COVER SHEET
FOR
PUYALLUP PUBLIC SAFETY BUILDING

PRCCP20030372
1st Review
May 2025

COVER SHEET
FOR PUYALLUP PUBLIC
SAFETY BUILDING BENAROYA
TENANT IMPROVEMENT PERMIT/BID SET

Sheet
C1

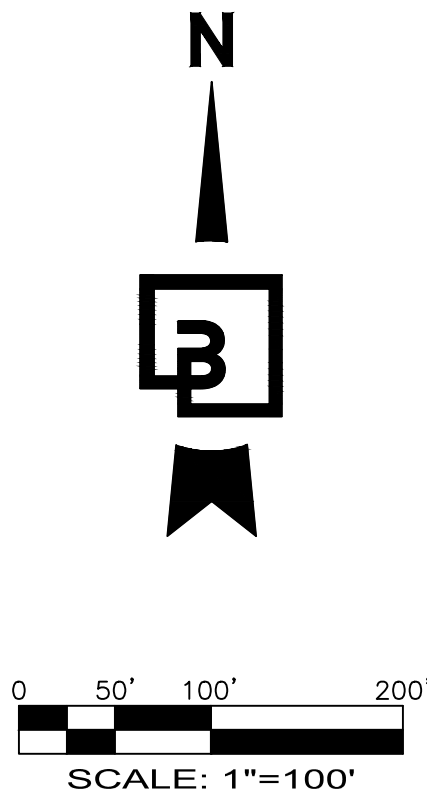
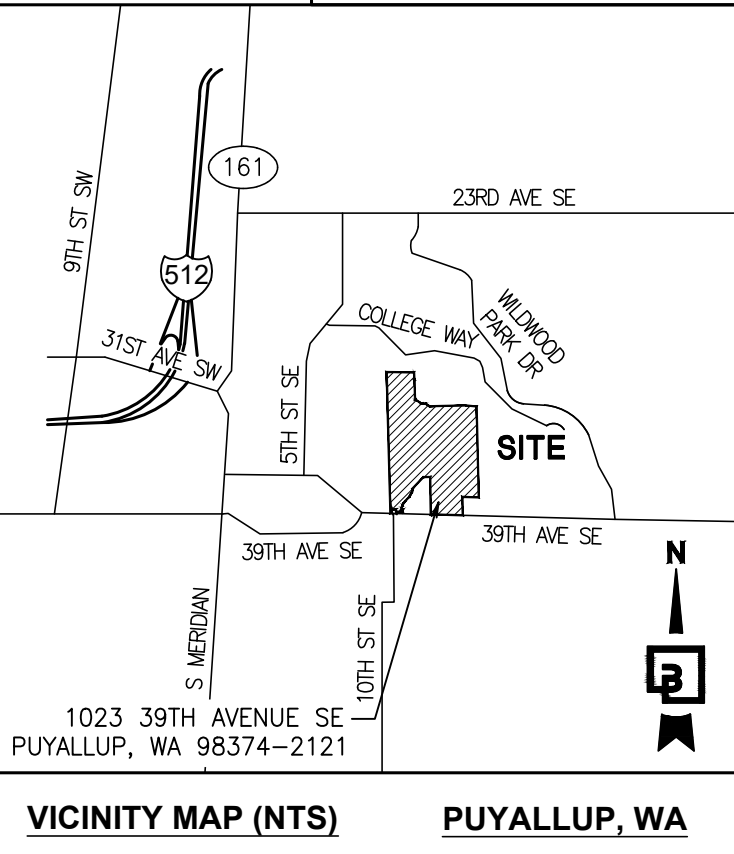
Add Note: "This project being part of an ongoing common plan of development which is greater than 1 acre, a Construction Stormwater General Permit shall be obtained from the Department of Ecology", or similar language.

Job Number
23796
Sheet
C9 of 9

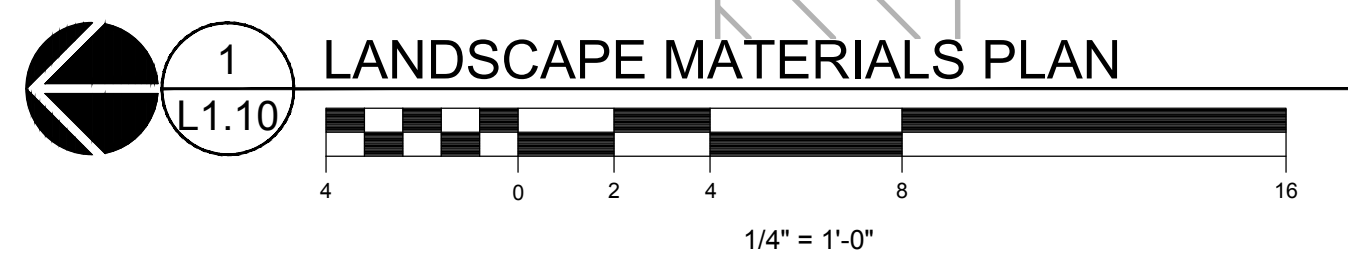
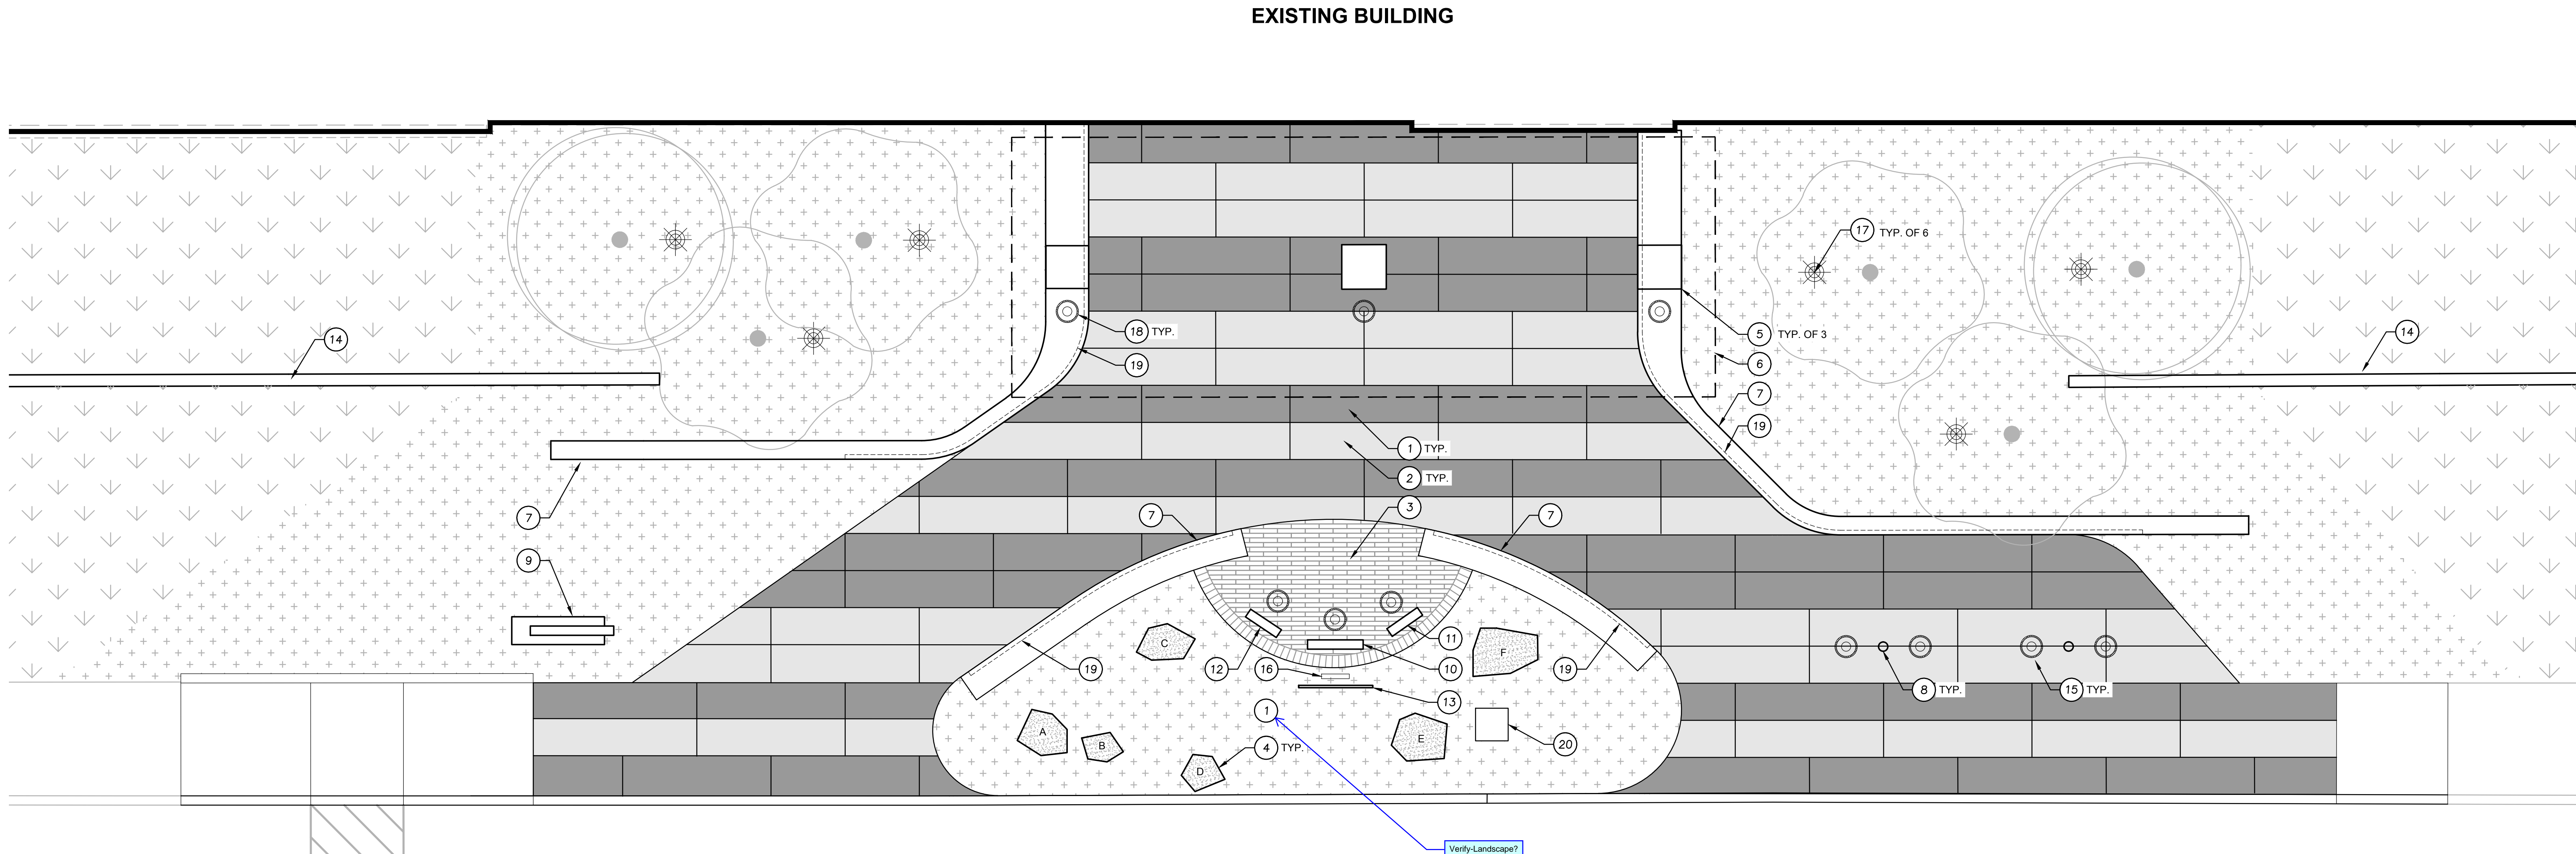
Add City Standard Details:
06.01.02
